MAINTENANCE OF TRAFFIC PHASE 2 STEP C
 STA 811+00.00 TO STA 0+50.00

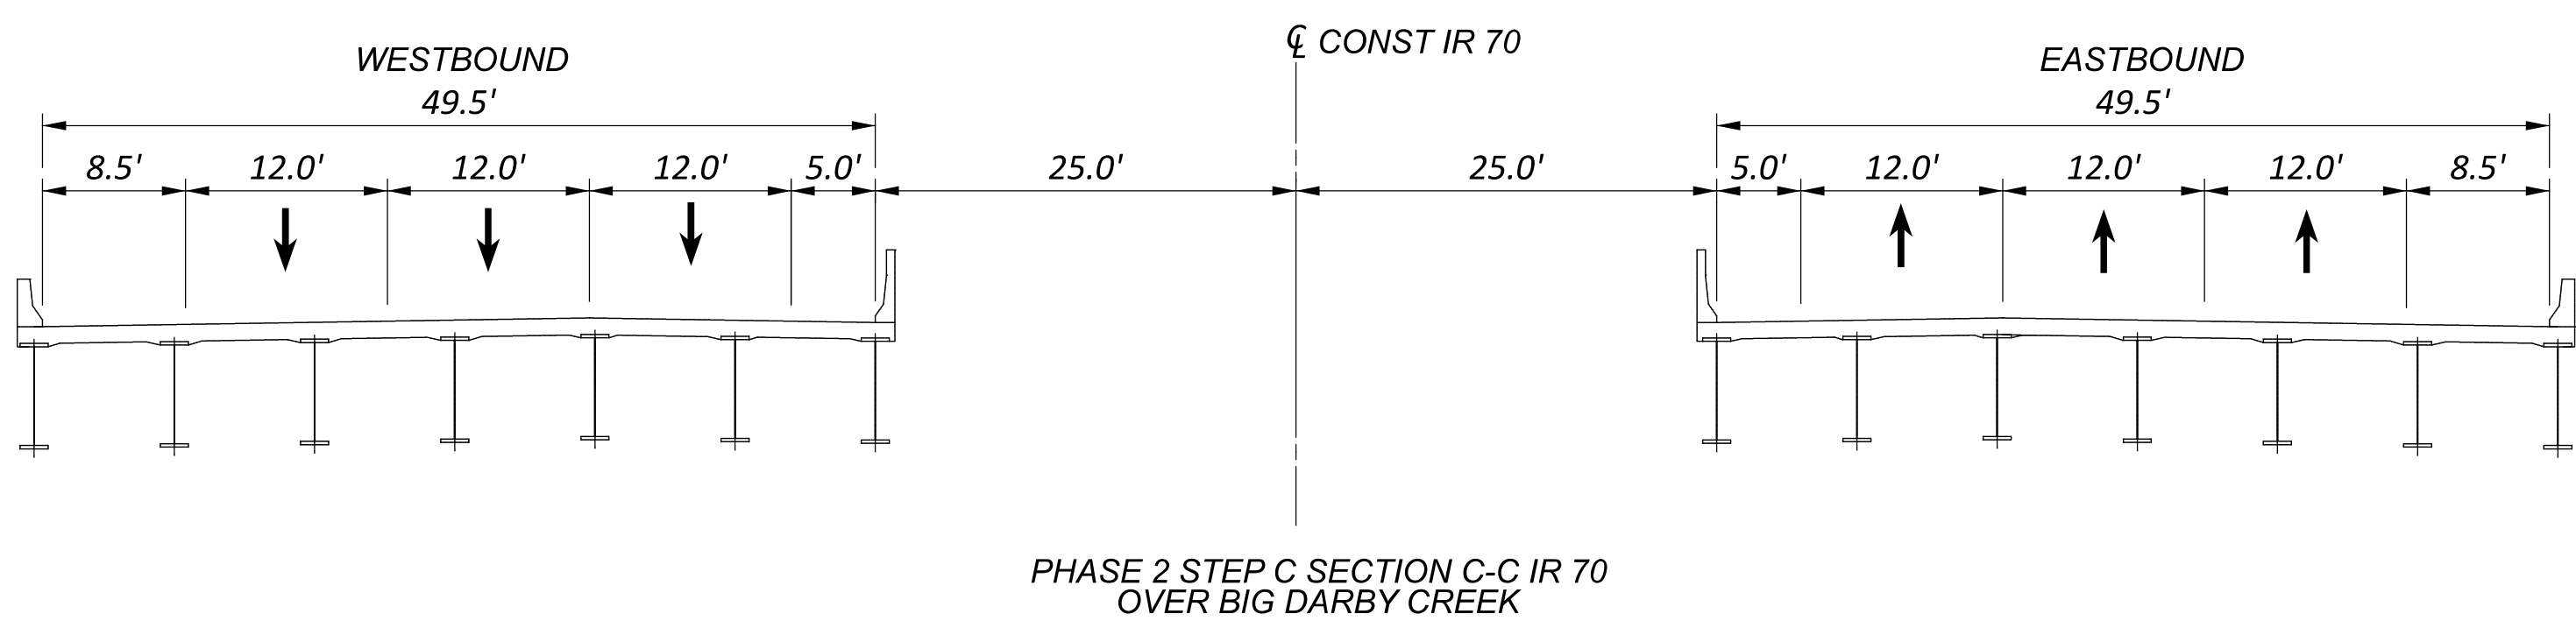
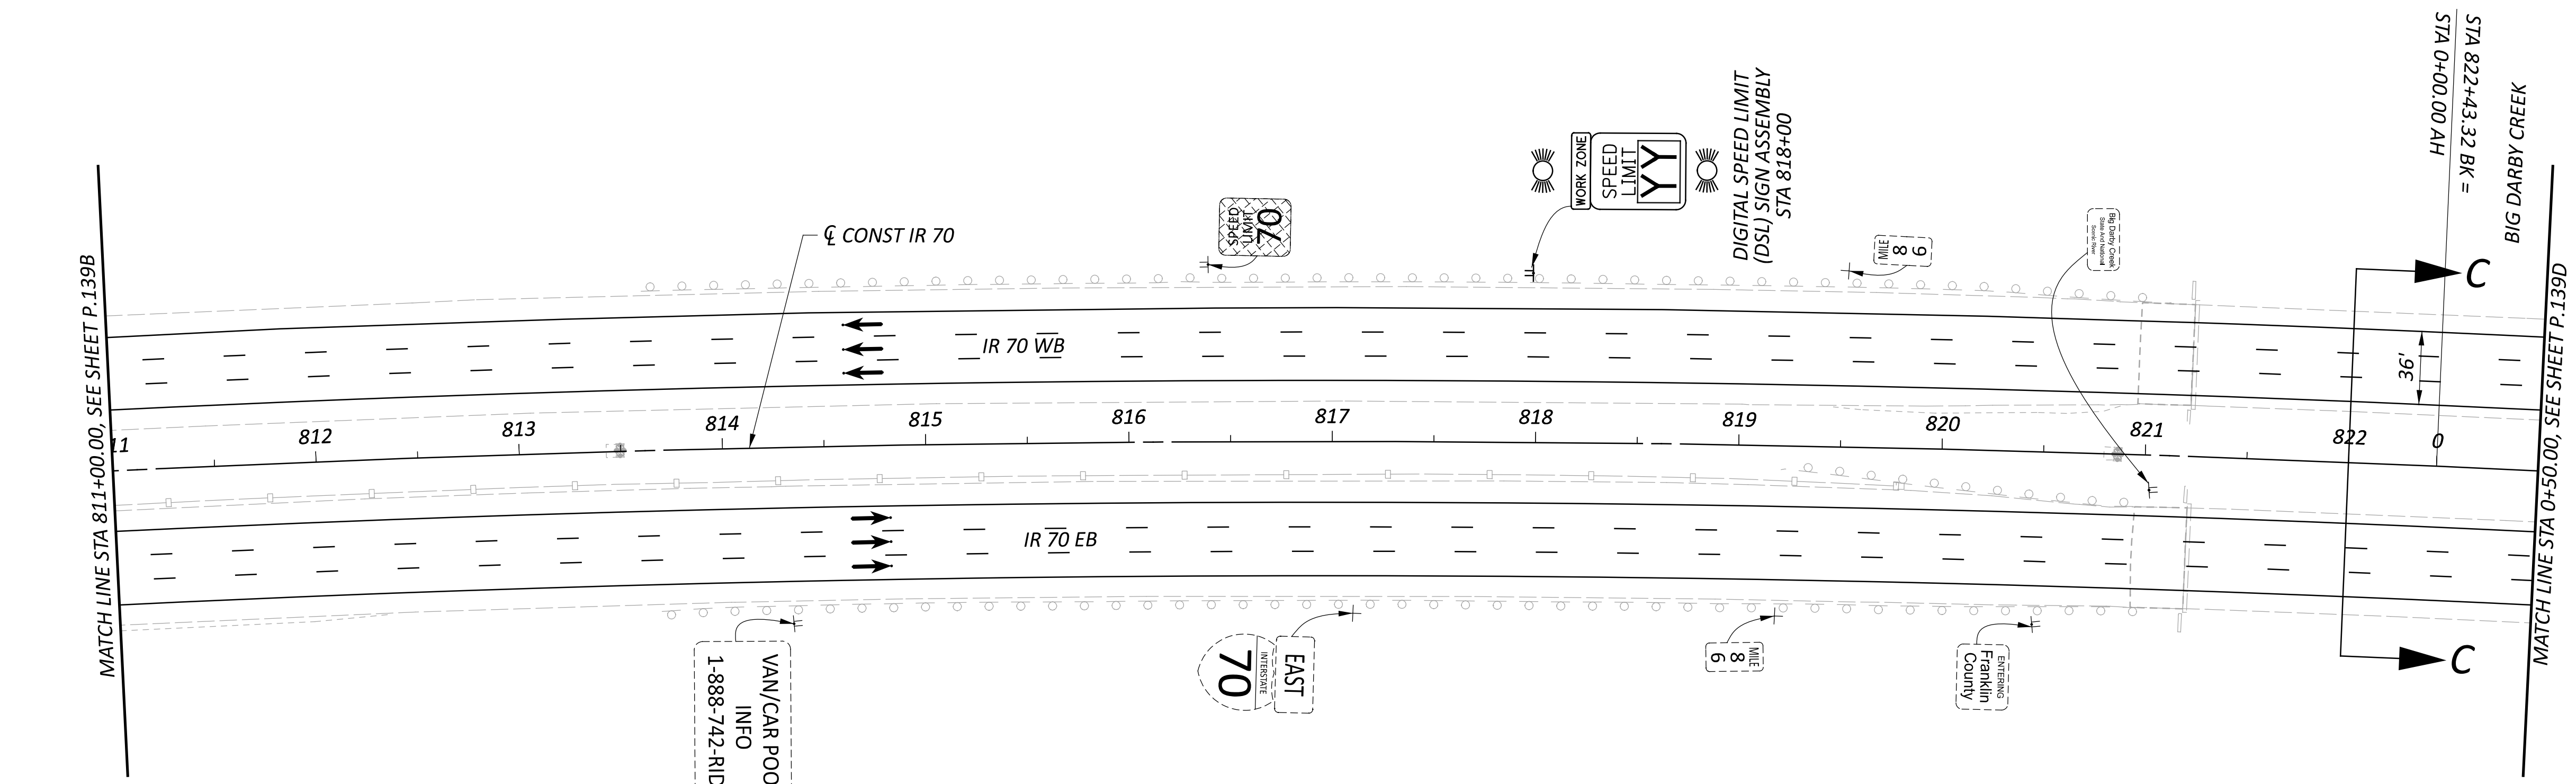
| REVISIONS | | |
|-----------|-----------|--|
| 2 | 1/22/2025 | PHASE 2 STEP C ADDED SHEET 139B ADDED |
| 3 | 1/28/2025 | SHEET 139A RENAMED TO 139C |

MATCH LINE STA 0+50.00, SEE SHEET P.139C

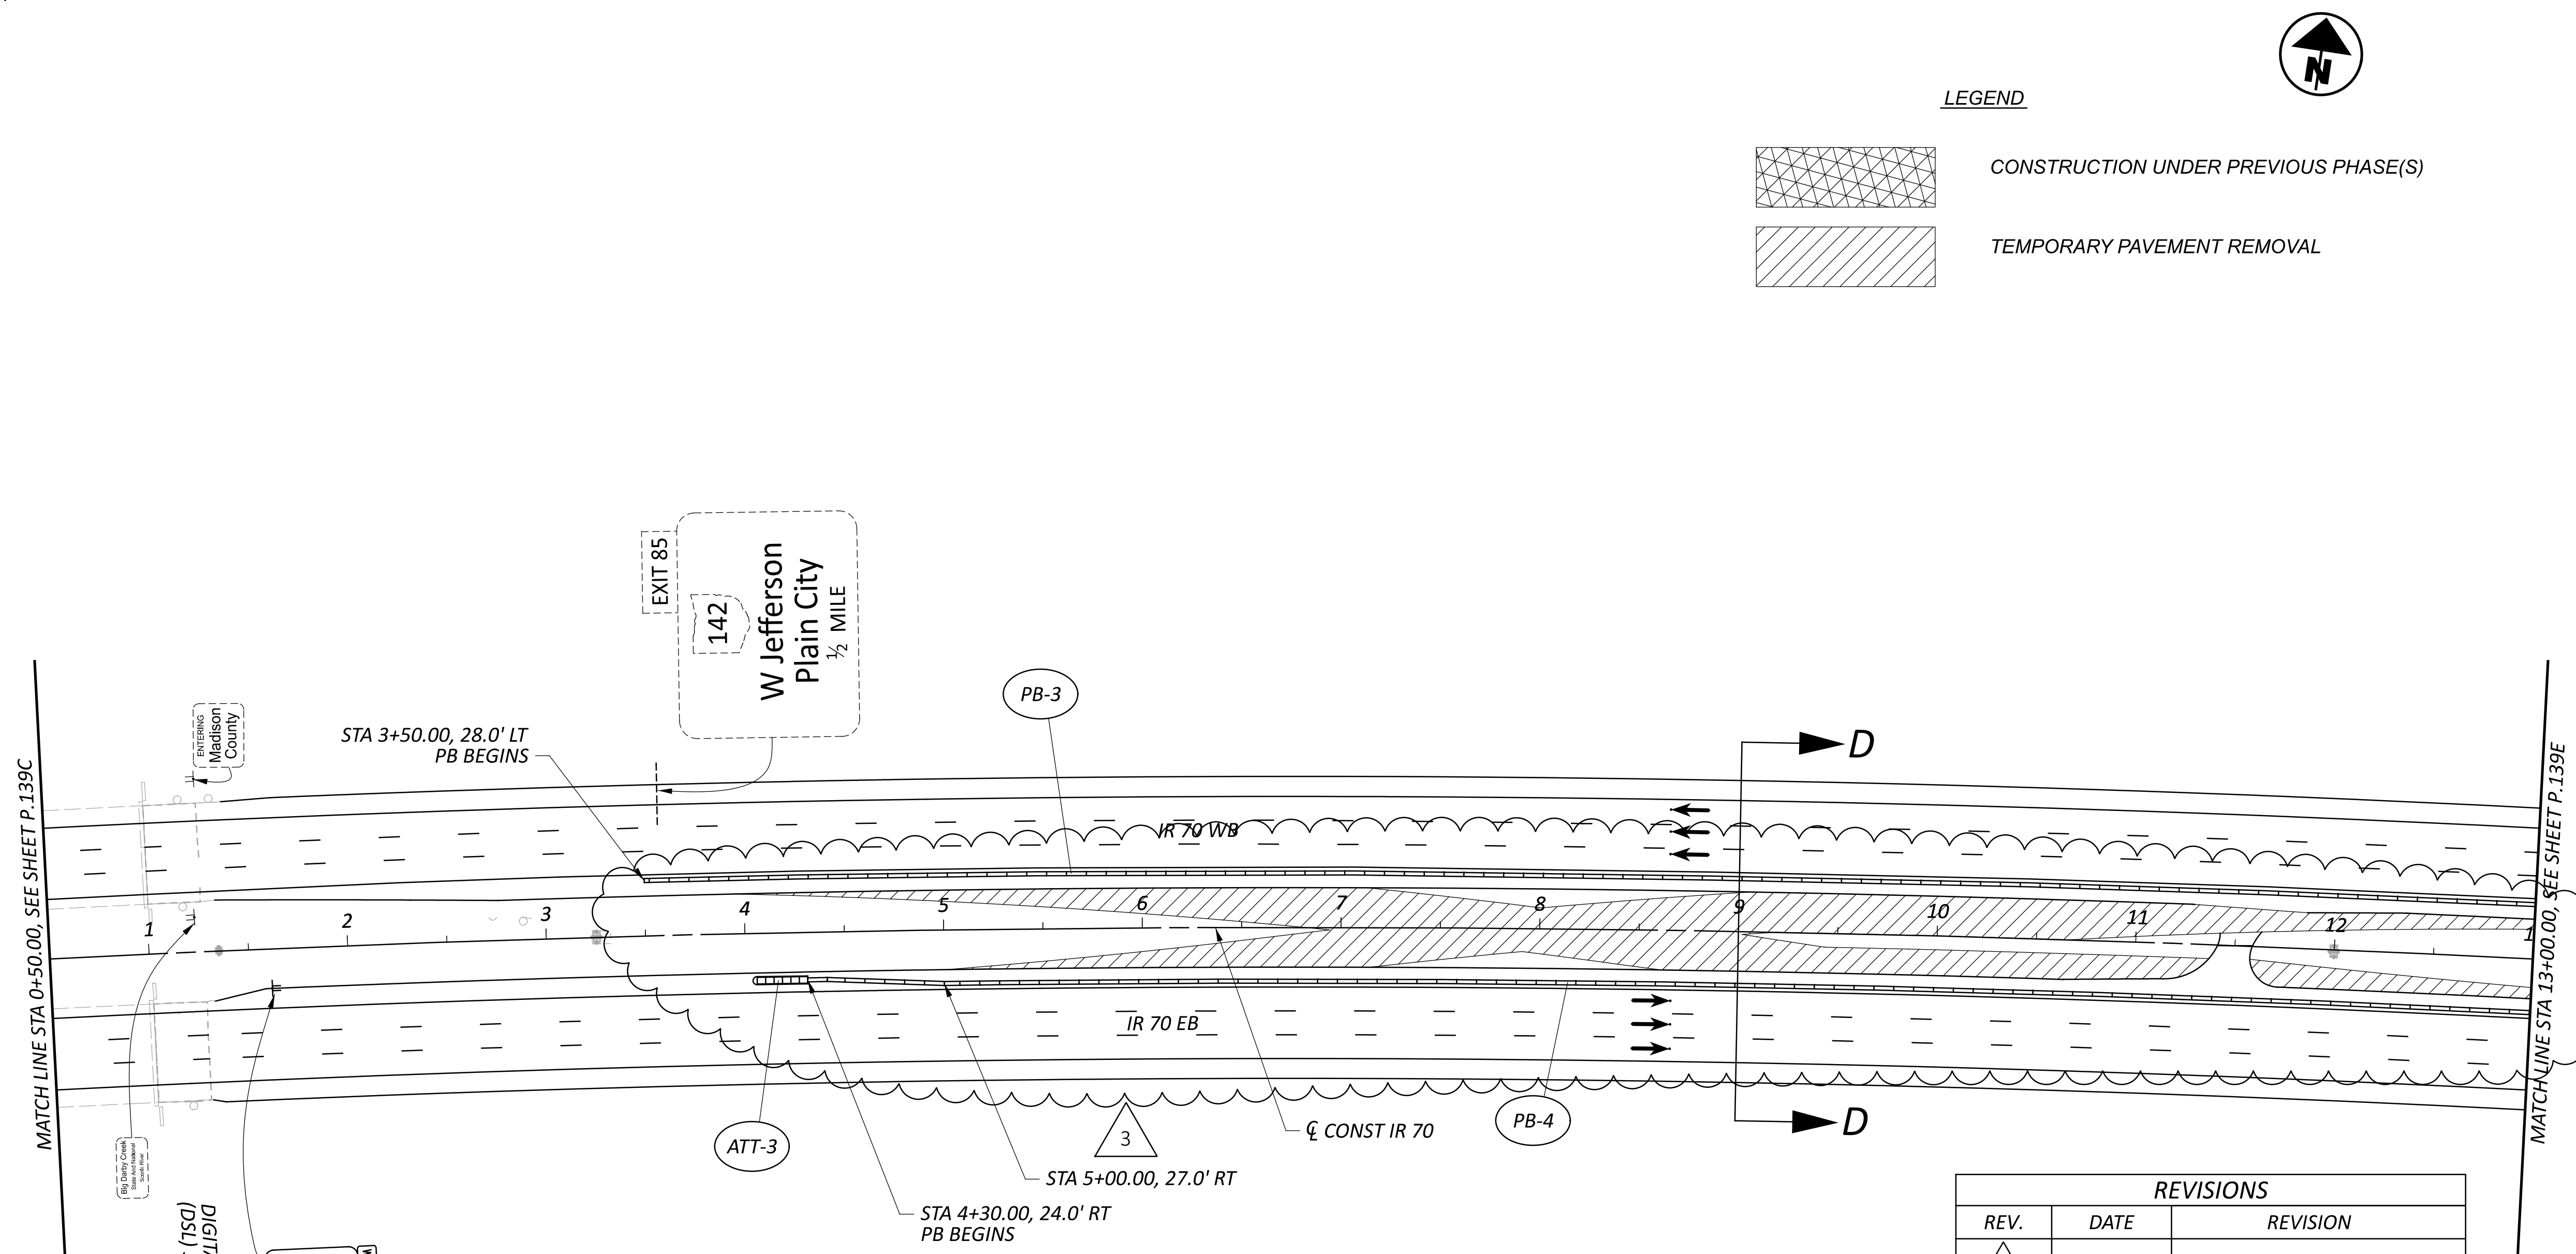
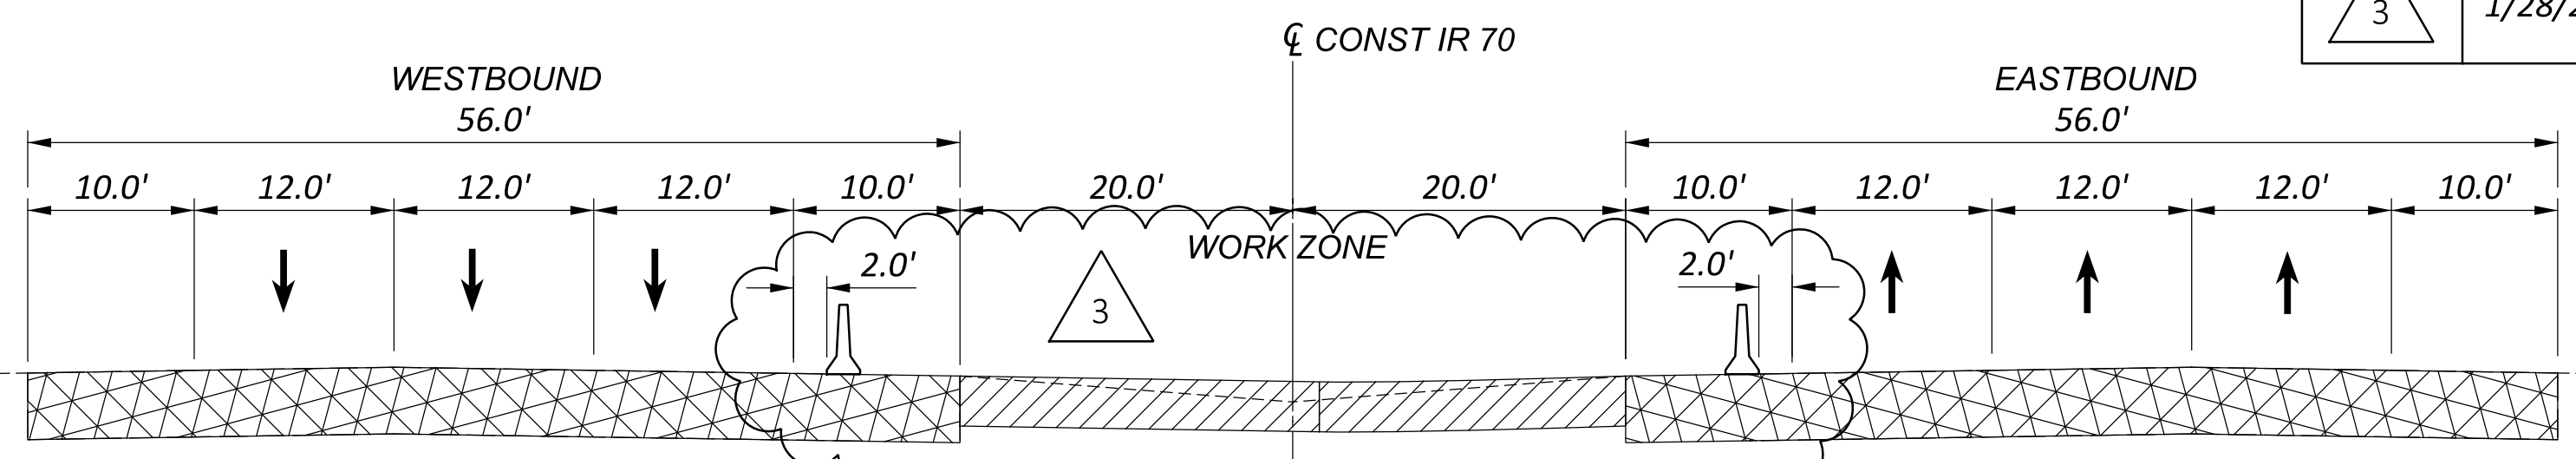
| REVISIONS | | |
|-----------|-----------|--|
| 3 | 1/28/2025 | TEMPORARY WORK ADDED SHEET 139B RENAMED TO 139D |
